3.5L GTDI—INTERMITTENT MIL ILLUMINATED WITH ONE OR MORE OF THE FOLLOWING DTCS P0236, P0238, P025E AND/OR P007D—BUILT ON OR BEFORE 2/15/2013

TSB 13-10-10

2011-2013 F-150

Figure 1 - Article 13-10-10

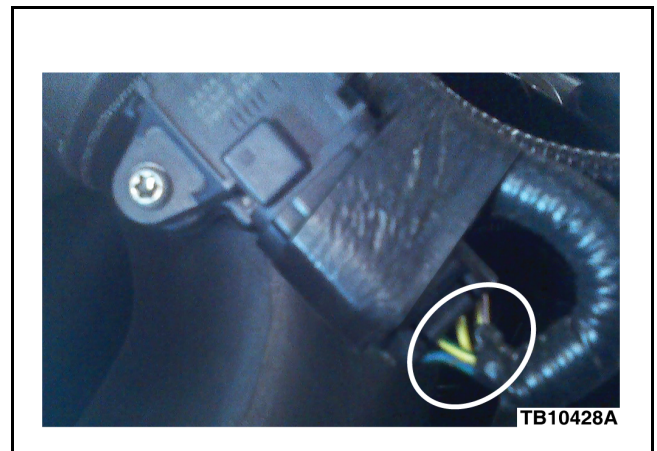
1. Using Integrated Diagnostic System (IDS), retrieve DTCs.
2. Are one or more of the following DTCs stored in the Powertrain Control Module (PCM); P0236, P0238, P025E and/or P007D?
 - a. Yes - proceed to Step 3.
 - b. No - this article does not apply. Refer to Powertrain Control/Emissions Diagnosis (PC/ED) manual for normal diagnosis.
3. Inspect for damage the wiring harness at the Turbocharger Boost Sensor connector C1588 for crack to wiring insulation. (Figure 1)
4. Is the wiring insulation damaged?
 - a. Yes - proceed to Step 5.
 - b. No - this article does not apply. Refer to PC/ED manual for normal diagnosis.
5. Install connector pigtail. Refer to splicing methods in Wiring Diagram, Section 5-1.
6. Using electrical tape, retain the harness to the connector shell with enlarged loop. (Figure 2)
